7 SUB2010-00121

A S SUBDIVISION

DETAIL SITE PLAN

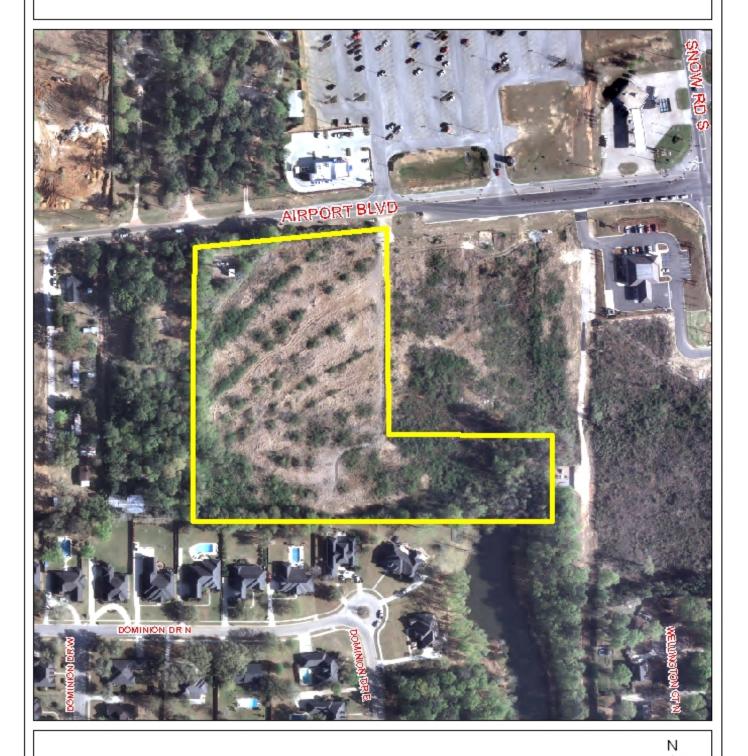
The purpose of this application is to create 3 legal lots of record from 1 legal lot. However, the preliminary plat illustrates the removal of a portion of parcel R022708280000131. (Lot 1), which currently has a MAWSS lift station. To remove the lift station from the parcel, it may be a separate lot, combined with another parcel and be included in this subdivision or remain in proposed Lot 1.

No building setback line is indicated on the plat; therefore the plat should be revised to indicate a 25' minimum building setback line along Airport Boulevard as measured from any required right-of-way dedication.

The plat proposes two curb-cuts for the 3 lot subdivision with Lots 1 and 2 sharing a curb-cut, and Lot 3 having its own curb-cut. As a means of access management and to allow the developer more flexibility, there should be a note on the Final Plat limiting the development to two curb-cuts with the location, size and design to be approved by Mobile County Engineering and to conform to AASHTO standards.

The proposed Lot 1 is also labeled as "Future Development". The "Future Development" label should be removed from the Final Plat, as typically such a label is only allowed if the remaining area is larger than 20 acres.

The lot sizes are not labeled on the plat, thus the plat should be revised to indicate their size in square feet.

- the applicant submit a revised preliminary plat illustrating the inclusion of the area of the MAWSS lift station within the proposed Lot 1, or establishing the MAWSS lift station as a separate lot of record;

- 2) placement of a note on the Final Plat limiting the development to 2 curb-cuts with the location, size and design to be approved by Mobile County Engineering and to conform to AASHTO standards;

- 3) depiction of the 25-foot minimum building setback line on the Final Plat;
- 4) placement of lot area size labeling, in square feet, on the Final Plat;
